Case 23021

Site Plan Approval for 1441 Hollis Street, Halifax

Design Review Committee September 10, 2020

Variances 1 & 2 – Maximum Height

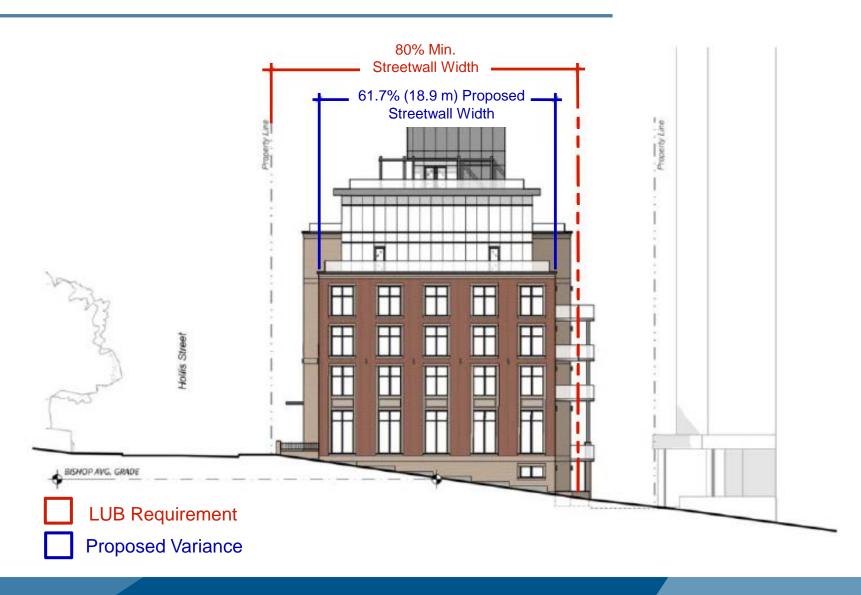
- Staff recommends approval based on the following:
 - ➤ 3.6.3 a. the requested variance is consistent with the Design Manual
 - ➤ 3.6.3 b. the modification is for a corner element used to join streetwalls of differing heights
 - ➤ 3.6.3 c. the streetwall height of abutting buildings is such that the streetwall height would be inconsistent with the character of the street
 - 3.6.3 d. where a landmark building element is called for pursuant to the Design Manual

Variance 3 – Streetwall Width

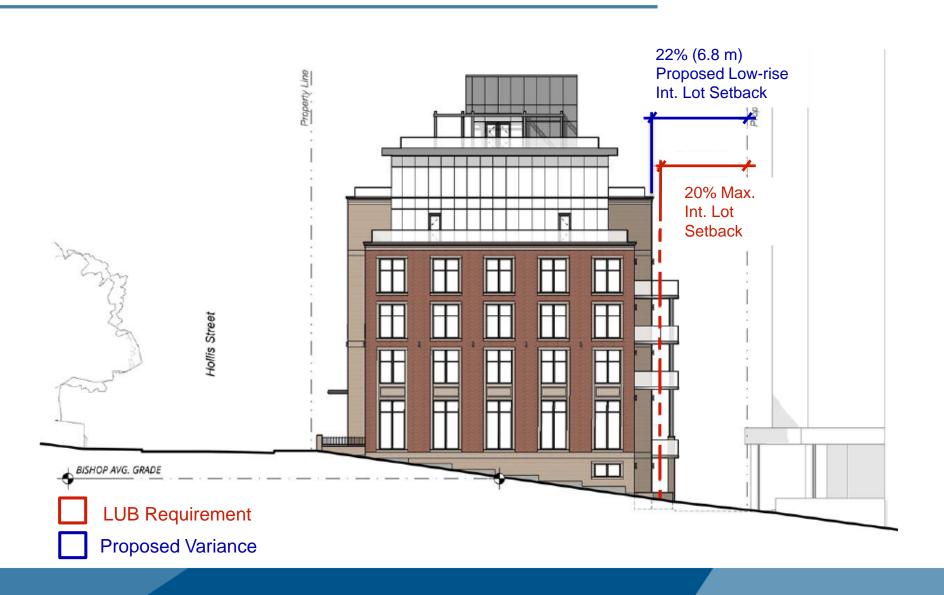
- Staff recommends approval based on the following:
 - ➤ 3.6.4 a. the streetwall width is consistent with the Design Manual
 - ➤ 3.6.4 b. the resulting gap in the streetwall has a clear purpose

Variance 4 – Setback from Interior Lot Line

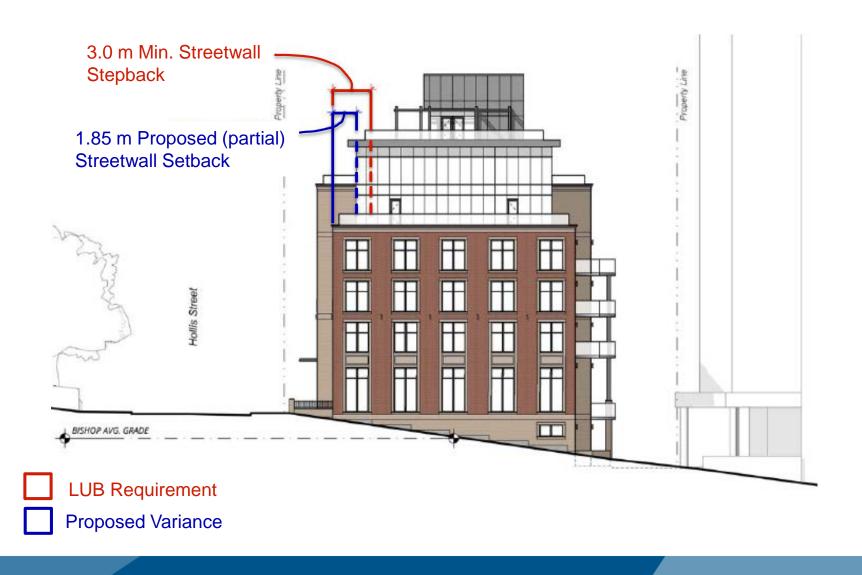
- Staff recommends approval based on the following:
 - ➤ 3.6.2 a. the streetwall width is consistent with the Design Manual
 - ➤ 3.6.4 b. the modification does not negatively impact abutting uses by providing insufficient separation

Variance 5 – Upper Storey Streetwall Setback

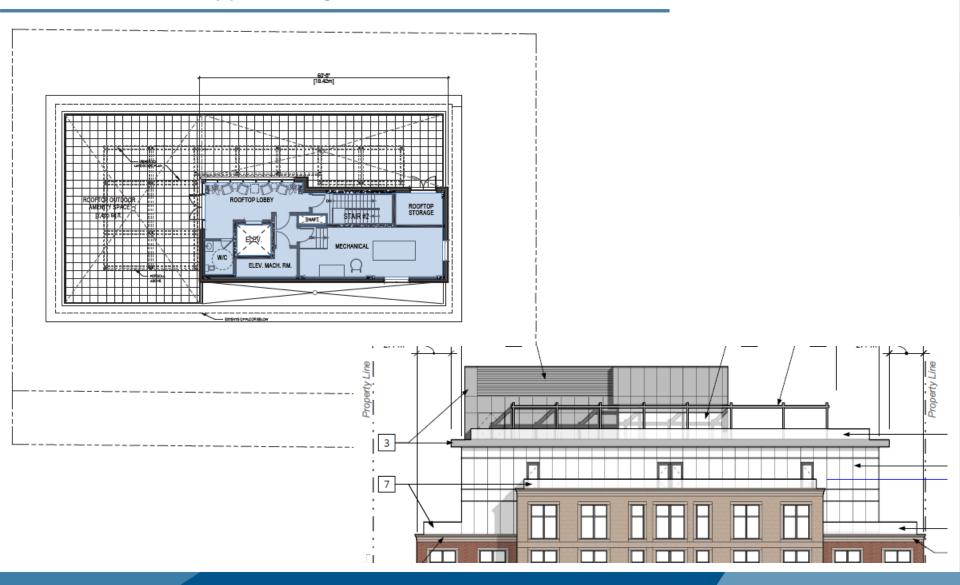
- Staff recommends approval based on the following:
 - ➤ 3.6.5 a. the streetwall width is consistent with the Design Manual
 - ➤ 3.6.5 b. the modification results in a positive benefit such as improved heritage preservation
